## Memorandum

To: El Paso County  
From: Brian Horan, PE, PTOE  
Date: May 16, 2024  
Re: **Owl Place Storage: Traffic Memorandum  
El Paso County, CO**

Figure 1 – Site Location

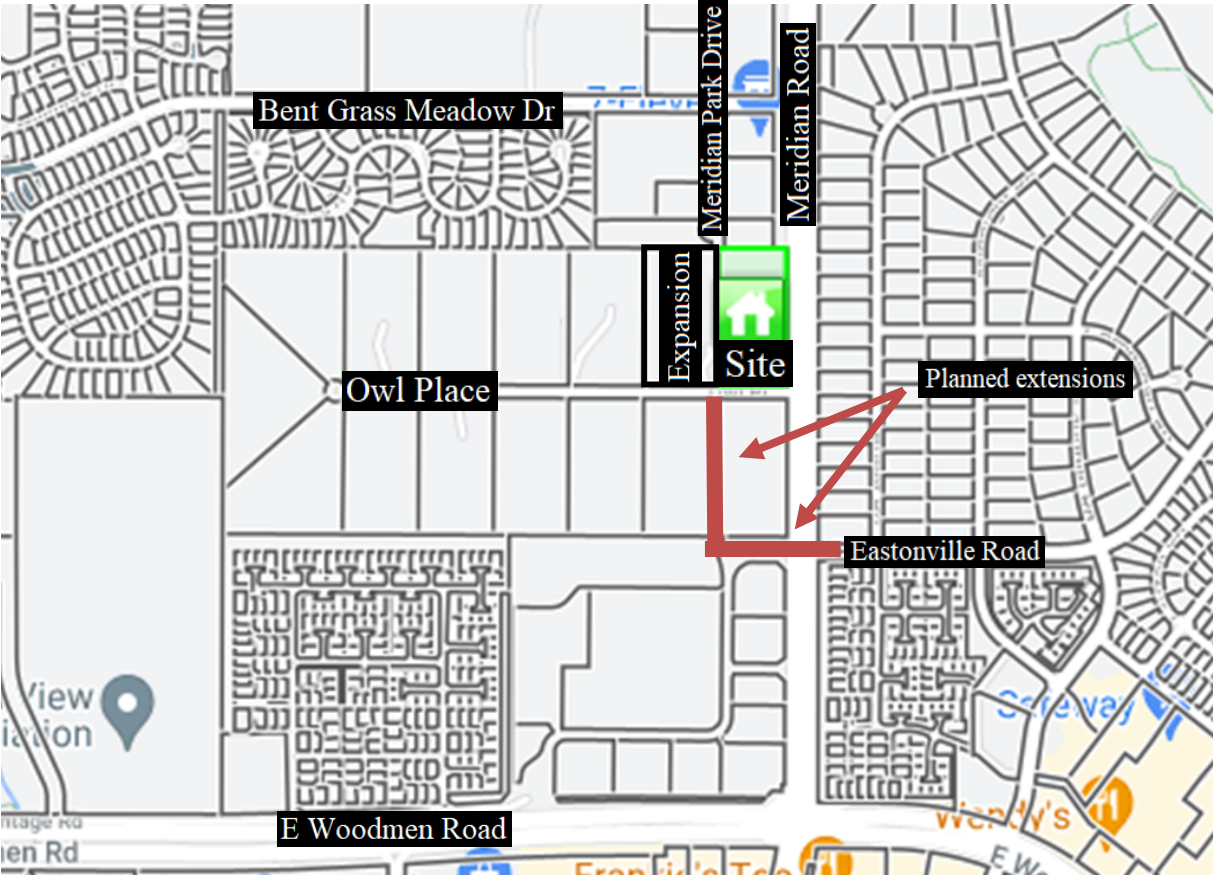
please provide  
standard County  
signature blocks

Added standard  
county signature  
blocks
